SERVICE BULLETIN	
	Flight Design GmbH Sielminger Str. 51 D-70771 L.-Echterdingen Tel +49 (0)711 90287-0 Fax +49 (0)711 90287-99 E-Mail: airworthiness@flightdesign.com	SB-ASTM-CTSW-07 Revision 00
		Date of Initial Publication: 30-Nov-2009 Publication Date of this Revision: 30-Nov-2009

Stabilizer Rear Wall Stiffening SB-ASTM-CTSW-07

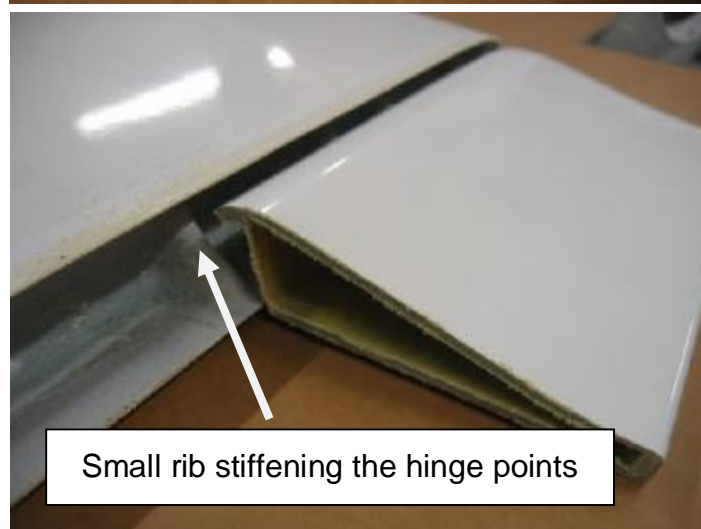
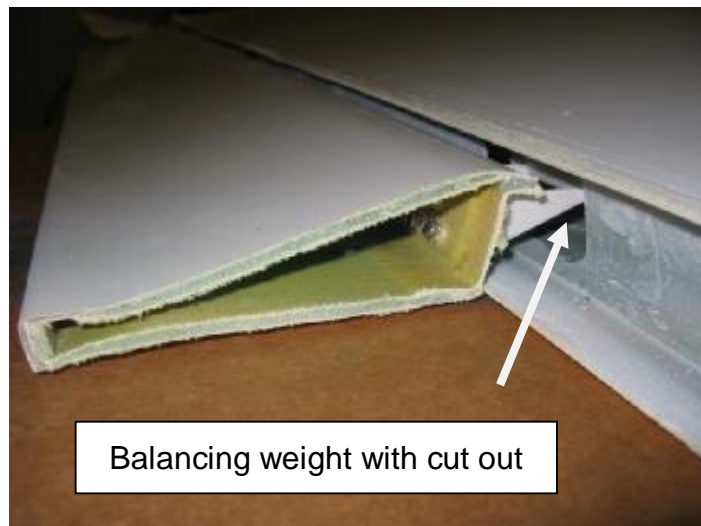
Stiffening of the rear wall of the stabilizer by installation of ribs in the cut-outs for the balancing weights, and direct support of the individual hinge points with small ribs.

Pictures in the Appendix of this SB illustrate balancing weights with cut outs and the small ribs, which supports each hinge point.
